TO: US and Canada Dealer Principals, Service Managers, Parts Managers and Sales Managers
RE: Recall R157 Volvo XC90 (MY2003 – MY2006) Outer Tie Rod End May Fracture

VOLVO				TITLE:	GROUP:	NO:
				Recall 157 Outer Tie Rod End May Fracture	64	157
Service Manager Bulletin				MODEL YEAR	ISSUING DEPARTMENT:	
				2003-2006 XC90	Warranty	
				REFERENCE BULLETINS:	CARMARKET:	
				TNN# 64-157 PB# 64-157 Supersedes: SMB 64-157 dated 2006-05-10	United States, Canada	
Service Personnel: read and initial.	SERVICE MANAGER	SERVICE WRITER	WARRANTY ADMINISTRATOR	DATE:		
				YEAR	MONTH	DAY
				2006	05	31
Page 1 of 3

NO: 64-157
DATE: 05-31-06
MODEL/ YEAR: XC90 2003-2006
CHASSIS: 275 0000001-0233242

SUBJECT Recall 157 Outer Tie Rod End May Fracture.
REFERENCE: VIDA, SMB 64-157, PB 64-157

1.

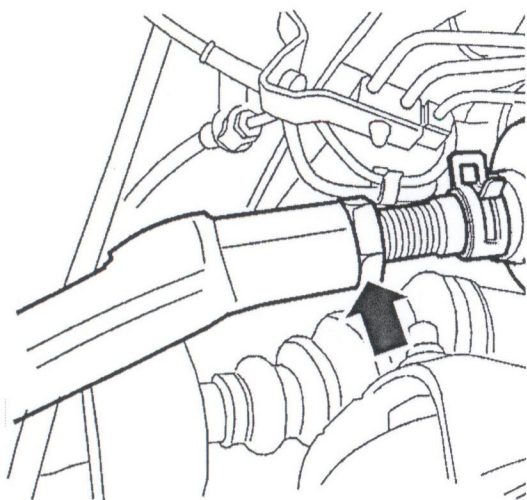
- The wheel
 - The outer tie rod from the spindle.
-
-

Installing the outer tie rod

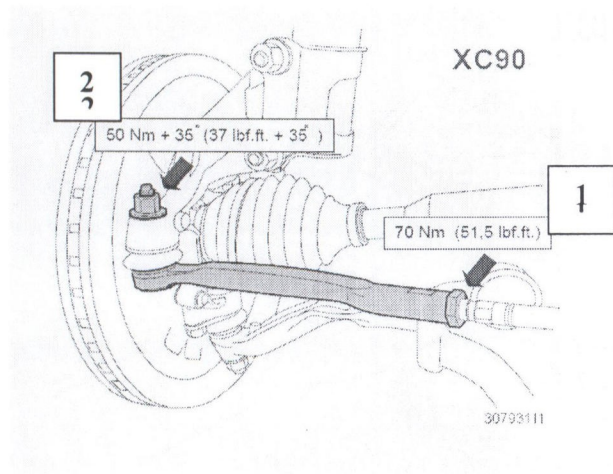
- The outer tie rod on the steering gear **1**. Torque the jam nut to 70 Nm (51.5 ft/lb).
 - The outer tie rod on the wheel spindle **2**. Use a wrench to counter hold the shaft, and tighten to 50 Nm + angle torque to 35° (37 ft/lb + angle torque to 35°).
-
-

Note! It is critical that the proper torque is achieved when installing the outer tie rods; only hand tools may be used. Do not use impact tools when installing the outer tie rod!
